Meeting: 8/16/2023
Project: New Hotel
Applicant: Tate Wright Elevate Architecture Studio

Level III Construction of a New Building/Structure

8-C-23-DT

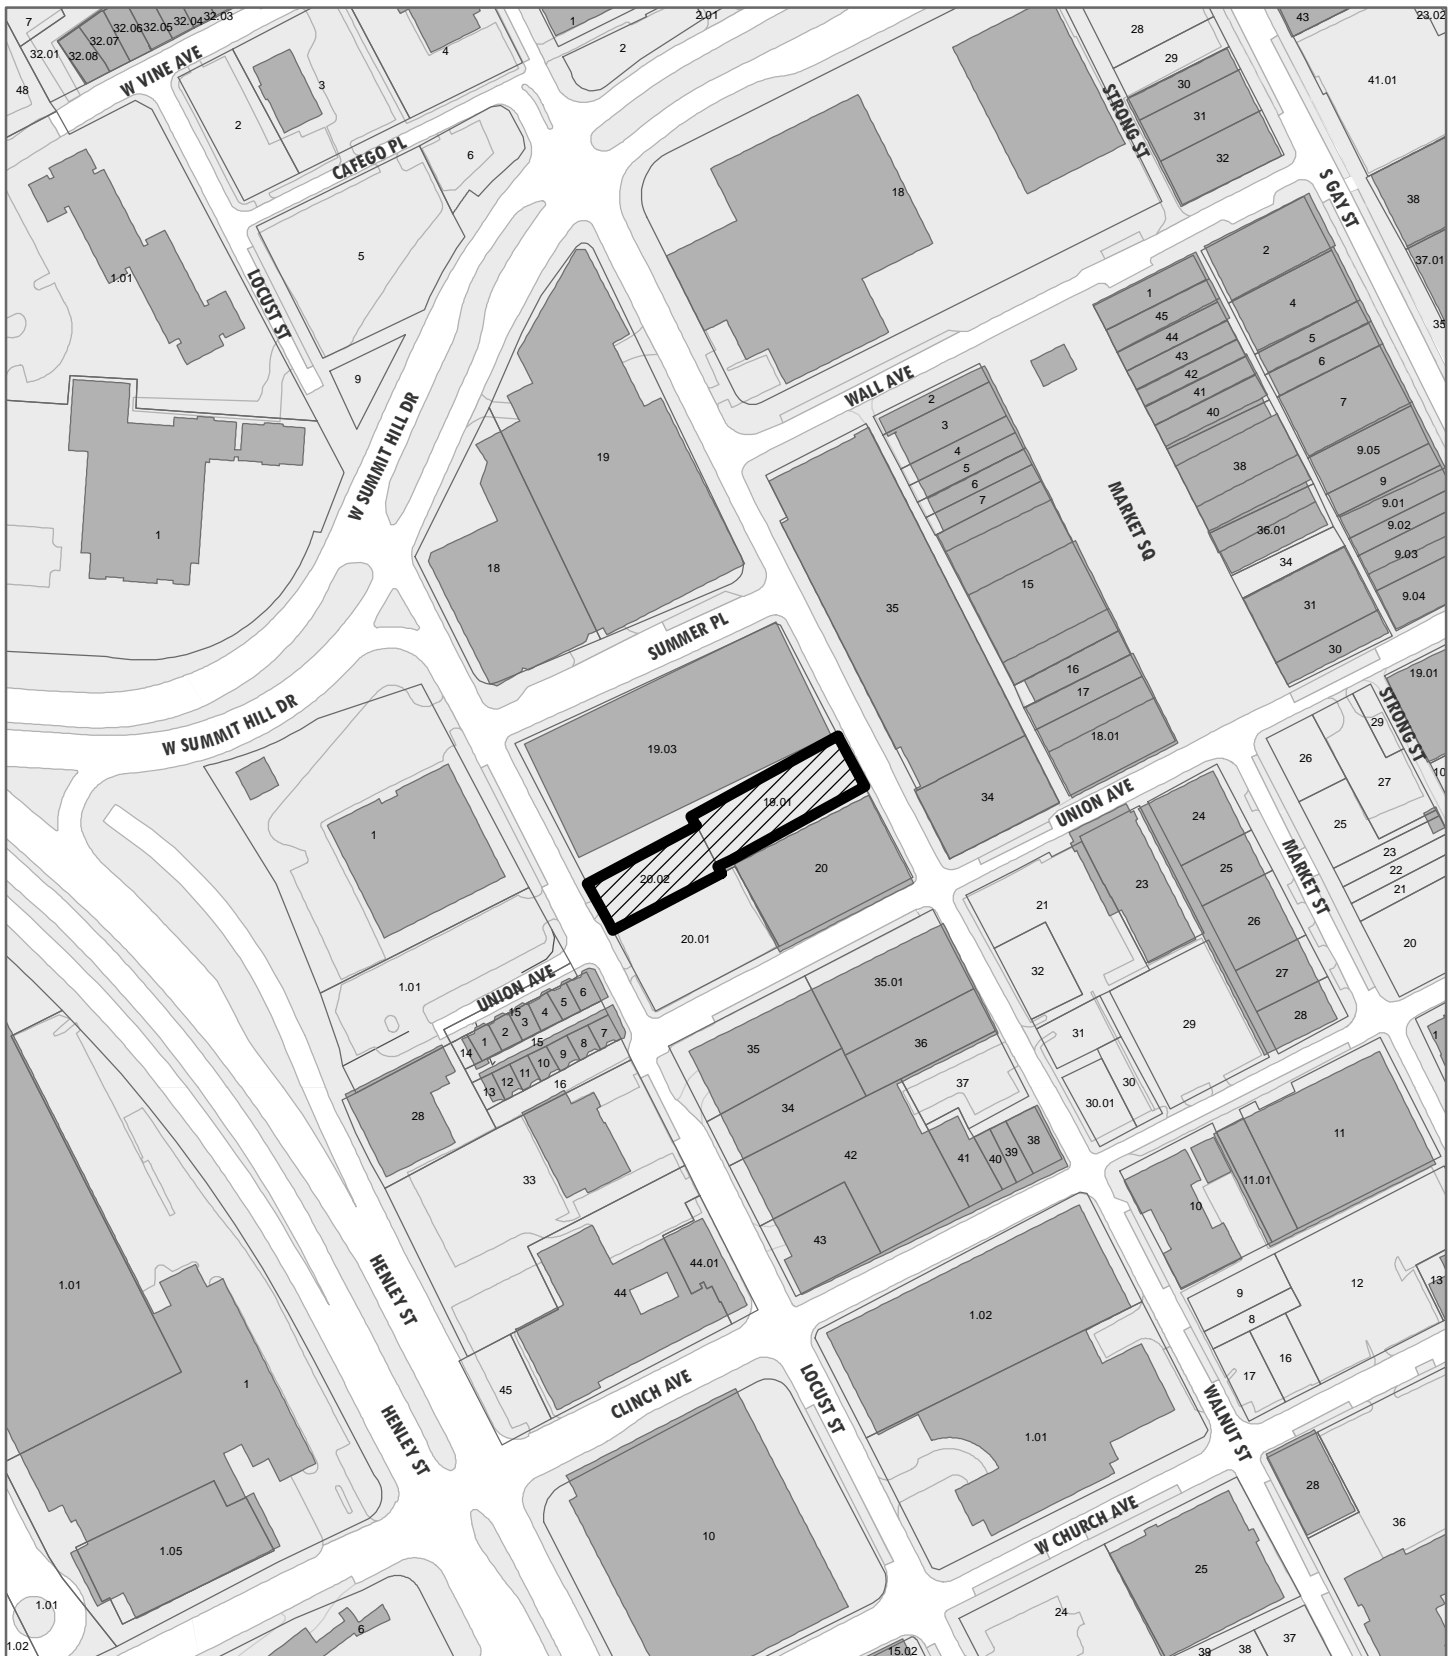
6. There are no public spaces on the Locust Street elevation. The elevation includes a service entry (a door with no transparency), a roll-up garage door, and a series of storefront windows opening to the employee break room. Hotel users or visitors will not be able to enter the hotel from this door. The employee break room will not have heavy use and does not feature a door to the street. The ground floor Locust Street elevation does not meet the design guidelines, as it does not contribute to the pedestrian experience, draw walk-in users, and lacks the transparency recommended to engage the street.

Staff recommends postponement of Certificate 8-C-23-DT, to encourage the applicant to 1) revise the ground-level elevations fronting both Locust Street and Walnut Street to meet the design guidelines and create pedestrian-oriented environments at street level; 2) meet with City Plans Review and Inspections to identify any access or zoning issues; and 3) address the potential height stepback requirement; along with any additional design comments identified by the Board.

1 EAST ELEVATION
SCALE: 3/32" = 1'-0"

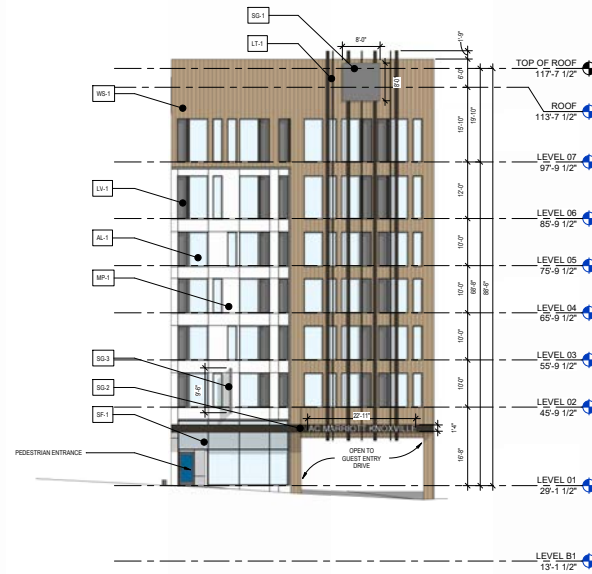
2. The application does not include on-site parking. However, almost all of the ground floor fronting Walnut Street is dedicated to automobiles, via a drive-through drop-off for hotel guests. Of the approximately 56' wide façade, 28'-

1" will be devoted to automobile entry and exit. Users of the hotel will either enter through a full-light pedestrian door on the left side of the façade and walk through the "covered outdoor waiting area," or walk on the auto access drive, to an entry vestibule recessed in the center of the building. Design guidelines encourage maintaining pedestrian-scaled environments from block-to-block, creating building materials and entries at a human scale to create an engaging pedestrian experience, using first-floor uses to draw walk-in traffic, and creating a transparent and consistent rhythm of entrances and windows at ground-level. The ground-level façade design fronting Walnut Street is primarily devoted to automobiles and does not meet the design guidelines.

3. City Engineering has not evaluated the driveway entry on Walnut Street, which will be approximately 125' from the entry to the Langley garage. There may be sight distance issues for cars exiting onto Walnut Street, and pedestrian safety issues crossing the sidewalk.

5. A small space marked "office/retail" is located on the left half of the façade, previously noted as a "rideshare drop-off" location in the June DRB workshop. It is unclear how the Marriott chain would connect with a secondary business for a 395 sq. ft. commercial space. The office/retail space does not sufficiently activate the streetscape for pedestrians, as there are no street-facing entry doors; the only entrance extends off the left side recessed entry.

1 SOUTH ELEVATION
SCALE: 3/32" = 1'-0"

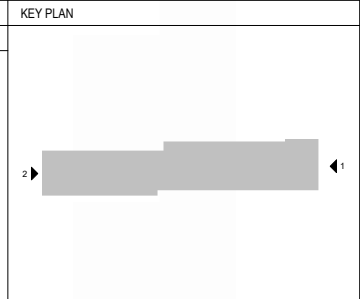
7. The south elevation will adjoin the residences on the rear elevation of the Walnut Building, including the basement-level residences which are currently separated from the surface parking lot by a fence and landscaping. The application lacks information on how the new hotel will engage the basement level residences. The light grey metal panel siding may have an adverse visual effect on the adjacent residences when in direct sunlight.
